**INTEROFFICE CORRESPONDENCE  
DEPARTMENT OF PUBLIC WORKS**

**TO:** Keith R. Sbiral, AICP, Planning & Community Development  
**FROM:** David H. Barber, P.E., Director of Public Works *DHB*  
**BY:** Michael D. Millette, P.E., Asst. Director of Public Works – Engineering *MDM*  
 Jonathan C. Hall, P.E., Development Engineer *JCH*  
**DATE:** July 5, 2005  
**RE:** Planning / Zoning Request  
 Proposed Nelson Meadow Subdivision  
 Public Works Department – **3rd Review**

Subject: 3<sup>rd</sup> Stormwater Management Review for Nelson Meadow Subdivision  
(CBBEL Project No. 01-528B263)

DRAWING NO. ST-1

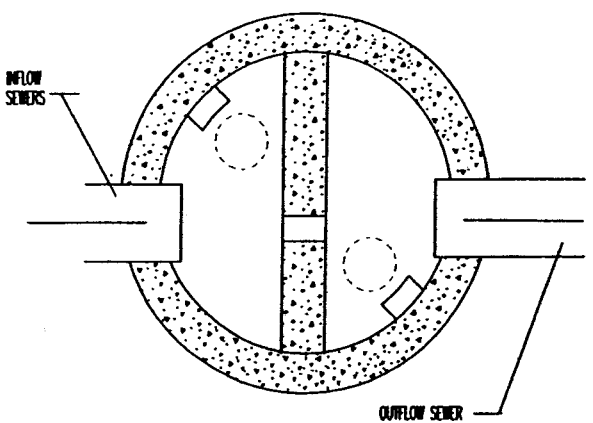
- Update PCC sidewalk detail to state ADA.  
**Accepted**
- Wire mesh is not needed in drive entrance detail.  
**Accepted**
- Update restrictor detail.  
**Not Accepted – Utilize standard design detail Dwg. ST-1 (attached)**
